# APPLICATION FOR BUILDING PERMIT

31 - 8 - 1960

Dwelling & Garage  
at Lincoln Rd

FLOOR PLAN FOUNDATION PLAN SITE PLAN DETAILS of GARAGE SERVERY KETTE CUPBOARDS

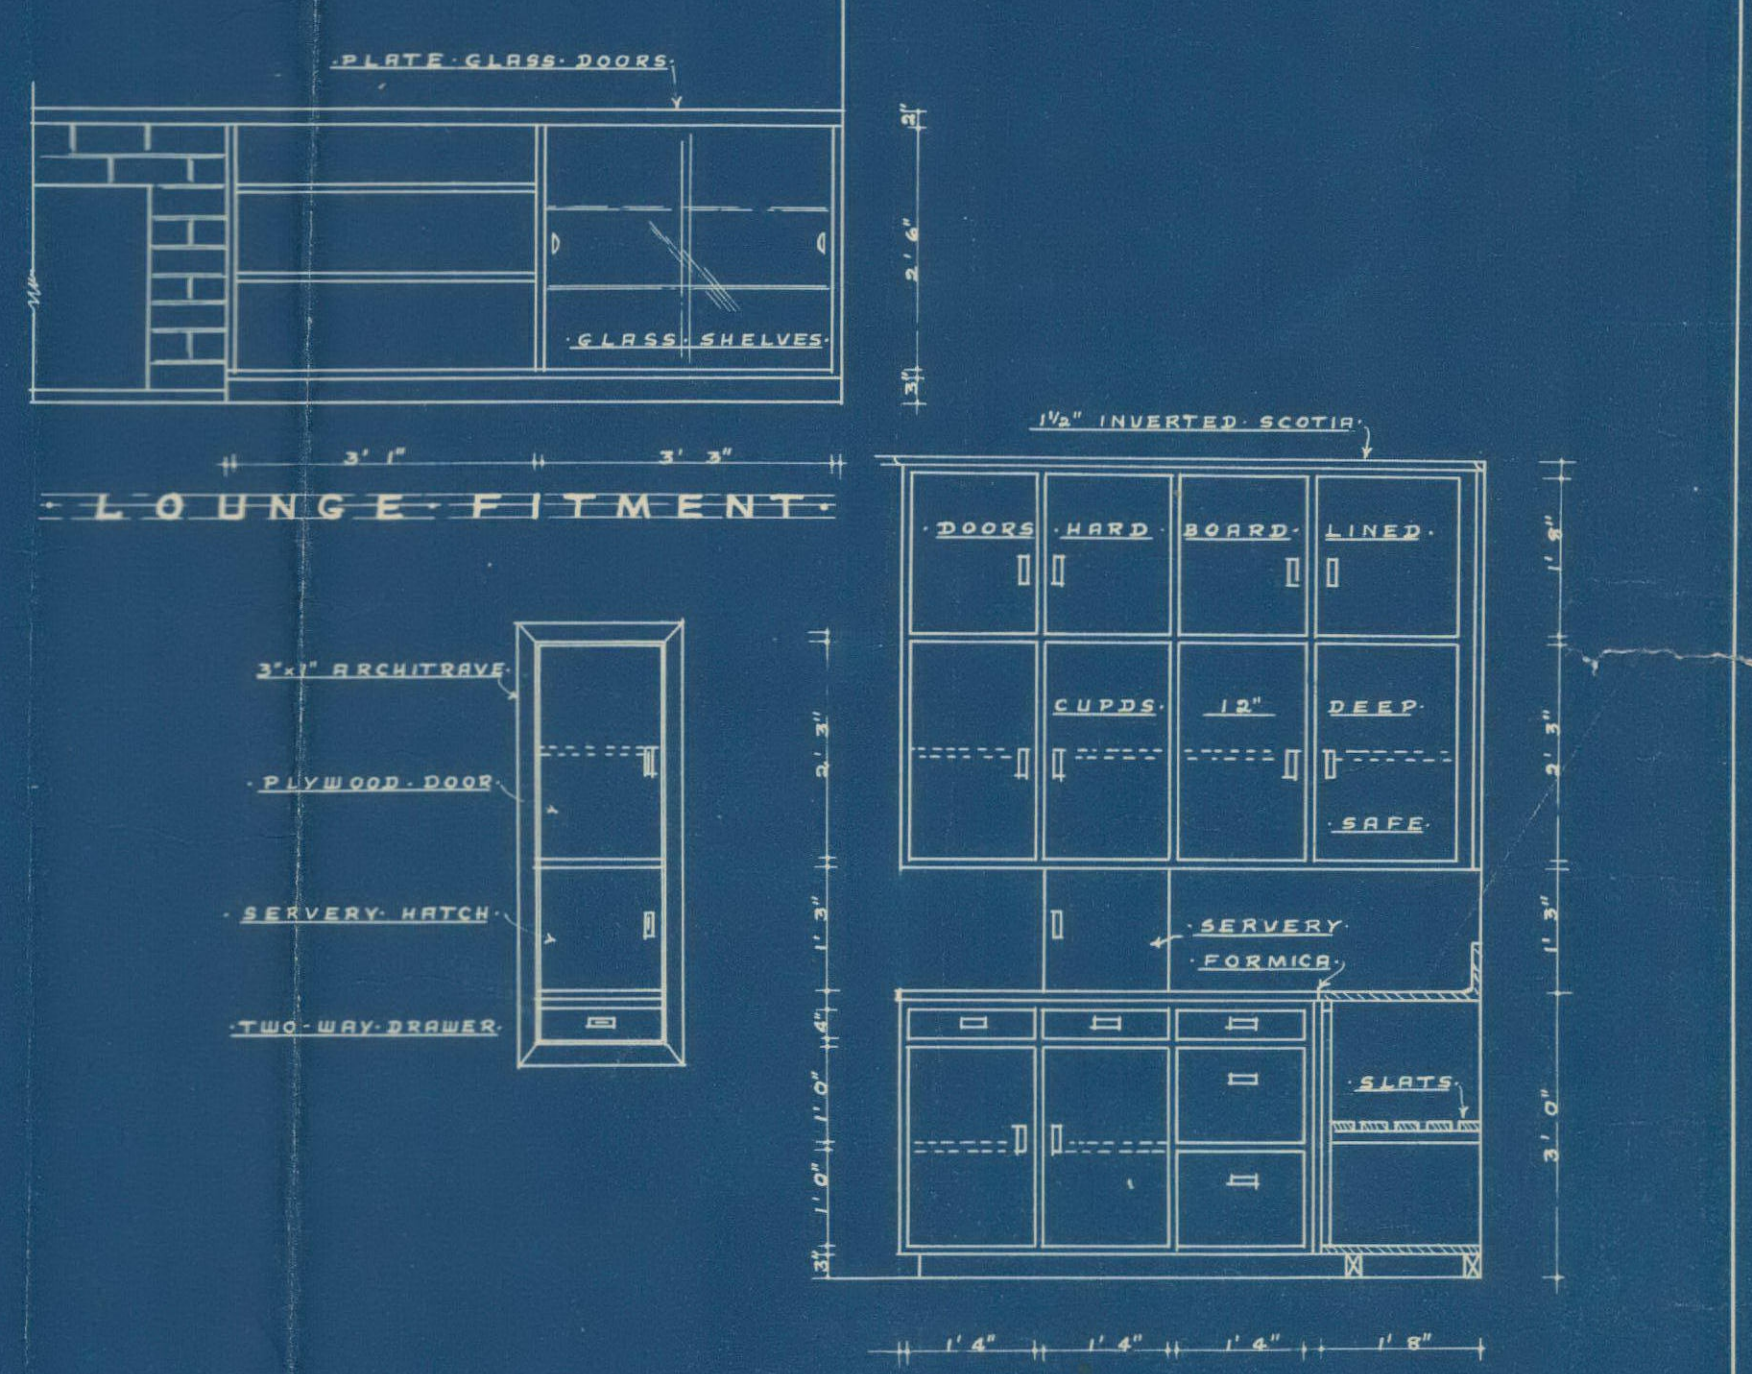
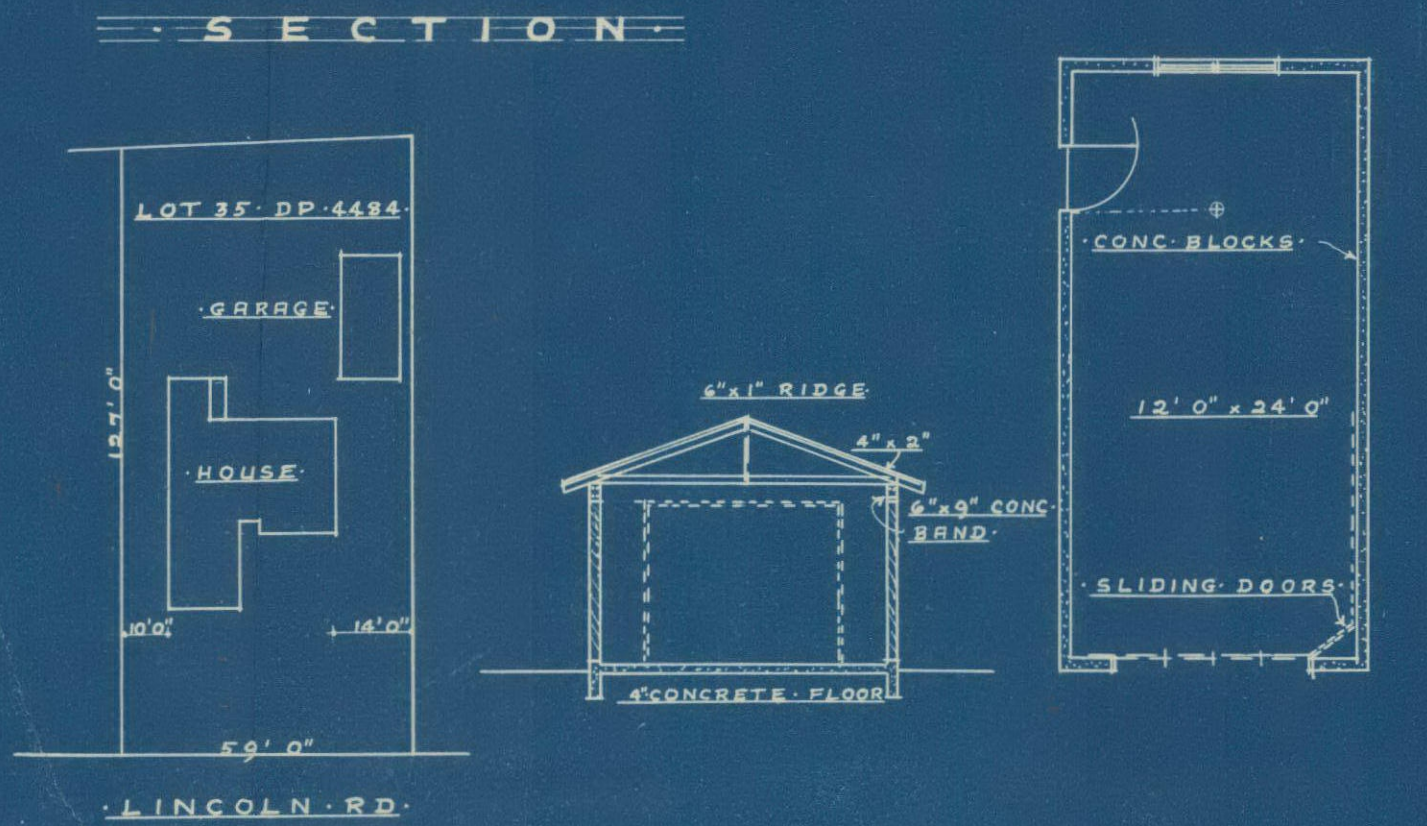
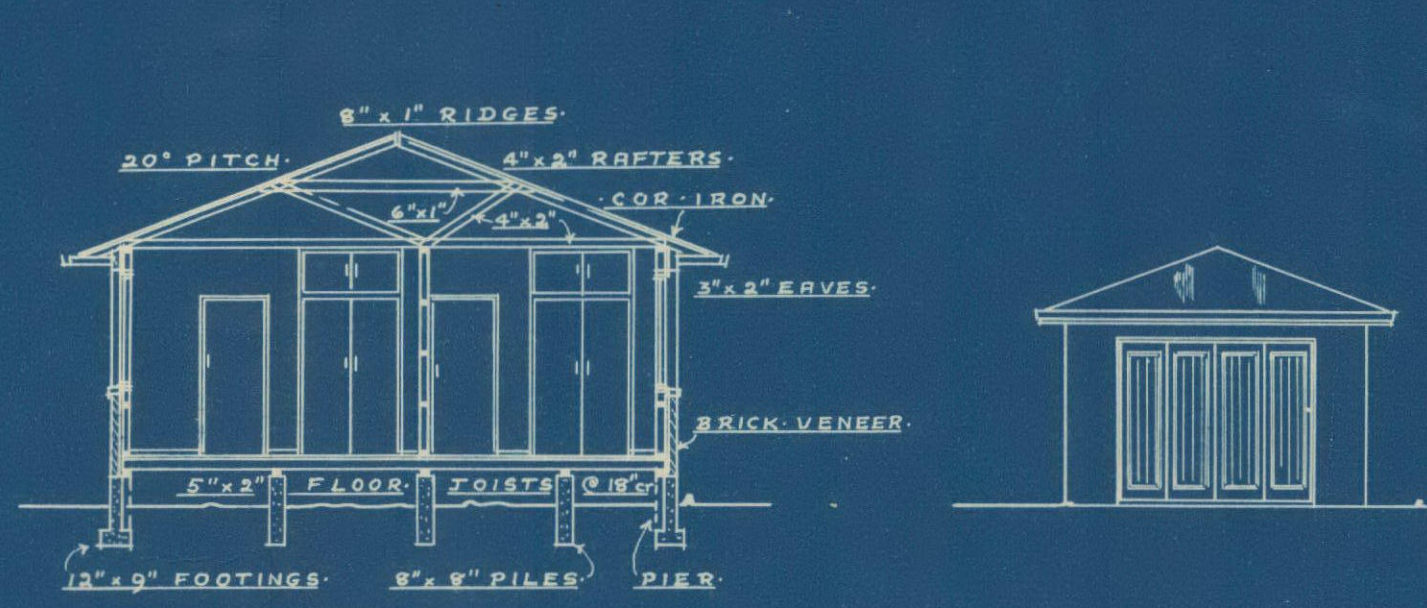
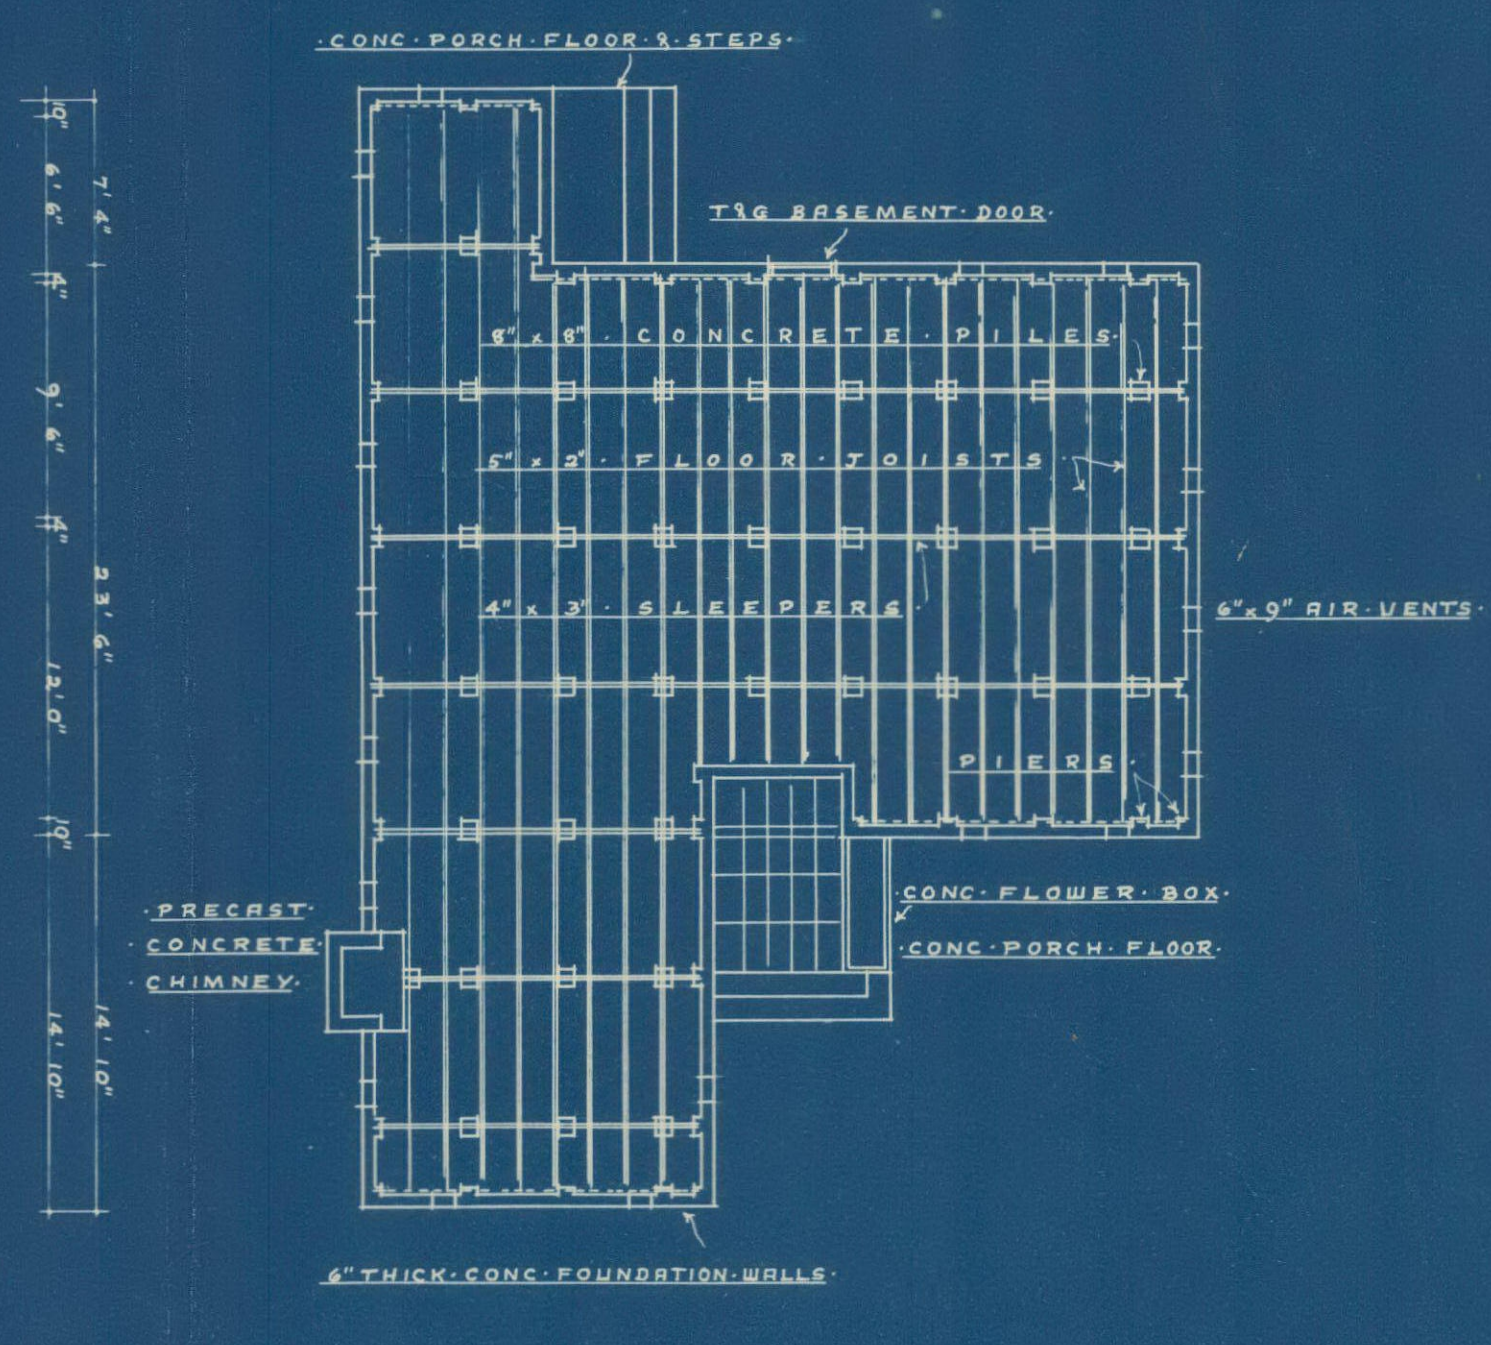
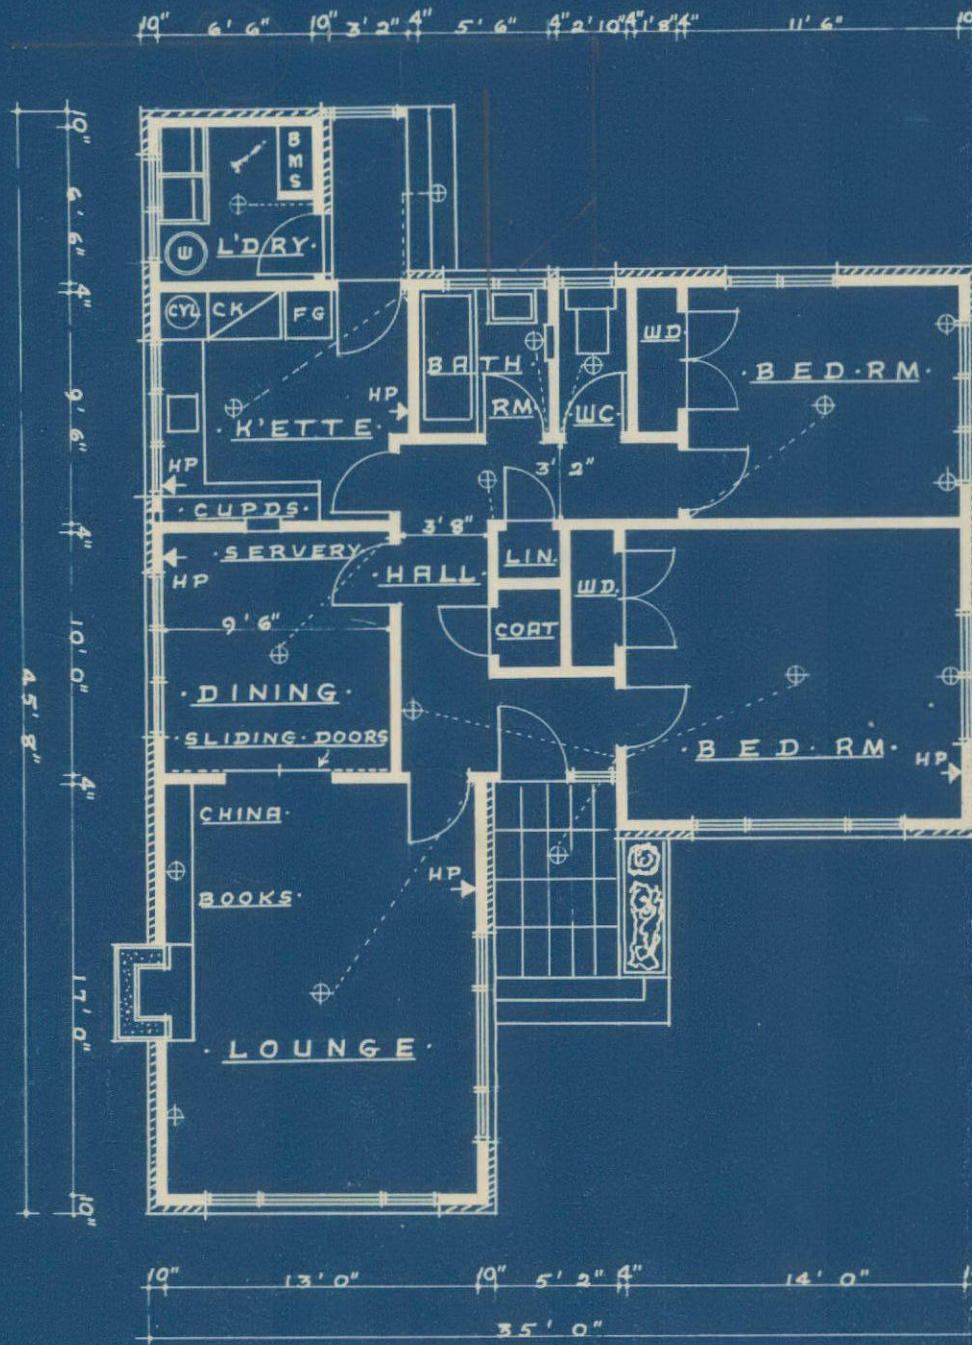
The sewer will be laid in this area within 3 months & dwelling must be connected, septic tank not permitted.

House not to be occupied until sewer is connected.

Contractor & sub-contractor to note amendment re roof water disposal & amendments agreed to. Permit to be issued on these conditions

- 1 It should be noted that Lot 35 has been subdivided & a corrected site plan will be necessary.
- 2 No distance from garage to boundaries given. It should be noted that all building <sup>33 feet</sup> from the new subdivision must be at least <sup>33 feet</sup> from the north west boundary.
- 3 No distance from front of house to boundaries
